Re: Phase 5 North Final Subdivision Plat

Thank you for your comments on the Final Subdivision Plat for Phase 5 North dated 18 May 2011. Responses to the comments are listed below.

Briar Chapel - Phase 5 North

*(Originally approved plan)*

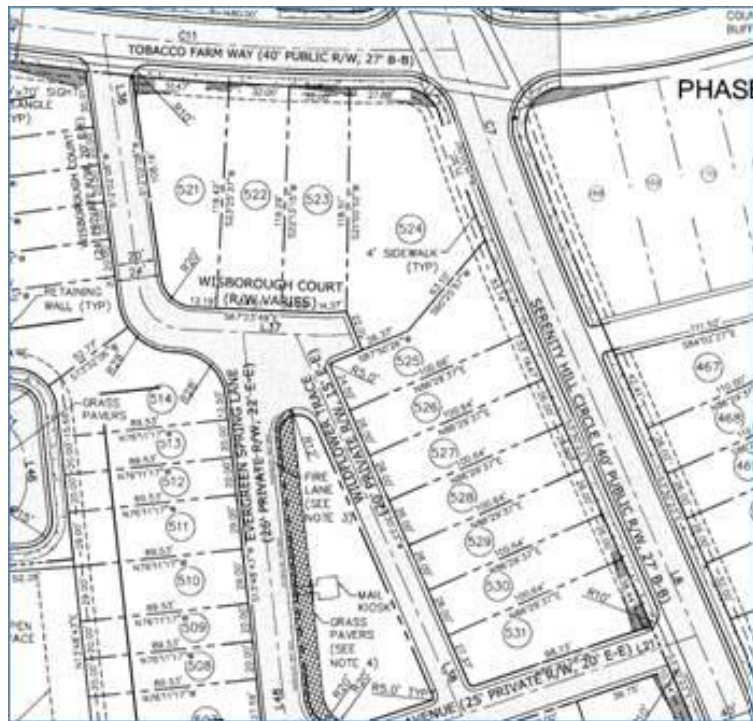
2. *Have engineer detail each change made between preliminary approval and final plat submittal.*

- A. Deleted lot number 626 as identified on preliminary plat due to height of retaining wall and significant area of slope within the lot. In the before and after images below, you can see there were originally 5 lots on the west side of Serenity Hill Circle, and in the revised plan there are 4 lots shown.

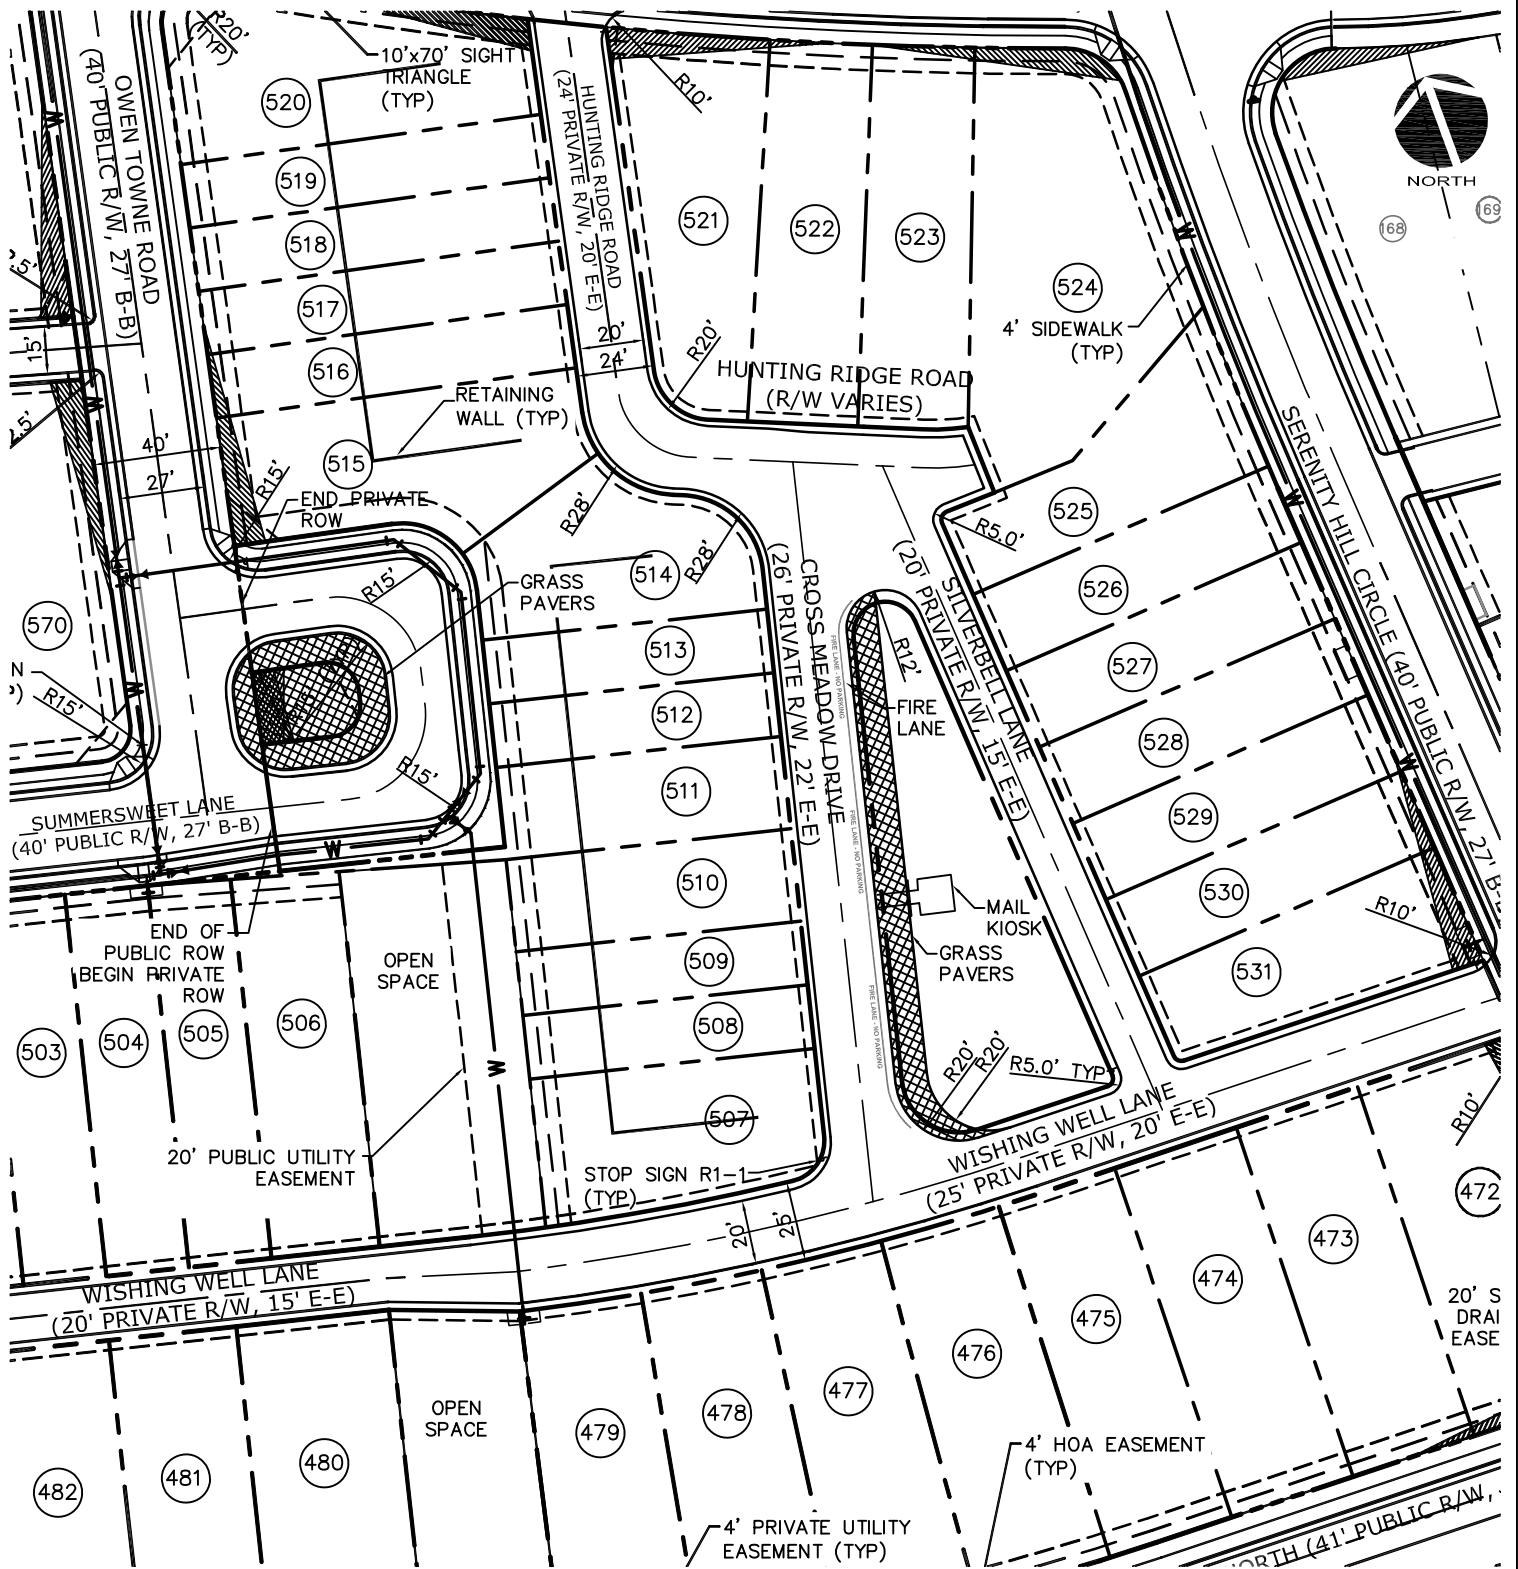
9. *Show grass pavers and parking spaces as specified in Note # 3, under Additional Notes.*

Response: Refer to Exhibit A that shows the grass paver area on Owen Towne Road and Cross Meadow Drive.

Exhibit A

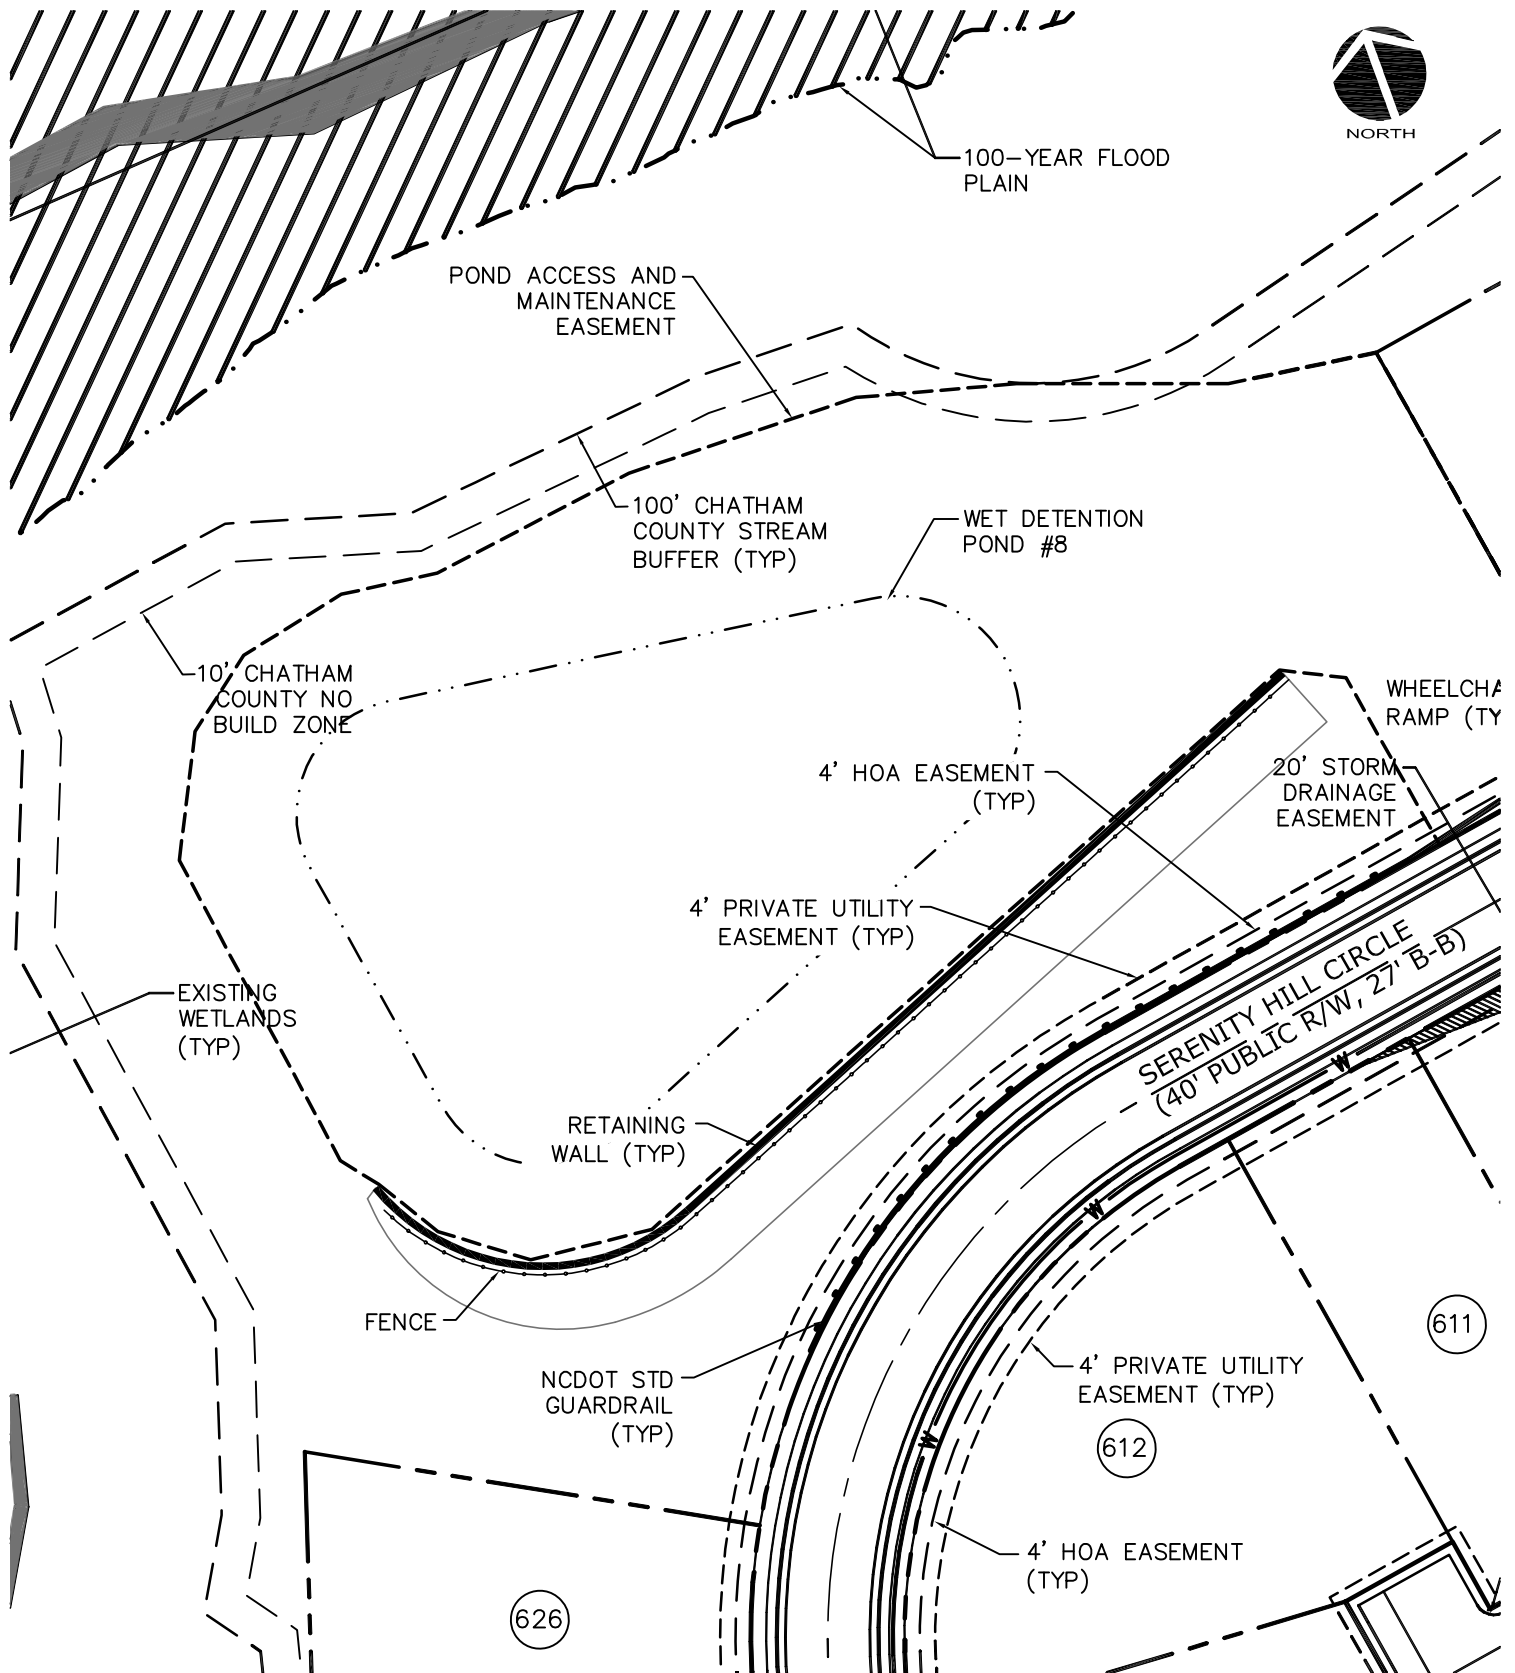
10. *Show retaining wall and easement locations. Per Rachael Thorn's inspections, she thinks the retaining walls are currently built.*

Response: Refer to Exhibits B and C that shows the location of the two retaining walls near Pond #7 and Pond #8. The walls are on the opposite side of the ponds from the conservation easement and the no-build buffer. An as built survey of the walls will be provided to the County once the ponds have been completed and the site is stabilized. The walls are constructed on property maintained by the HOA and therefore will not require easements such as those found in Phase 5 South.
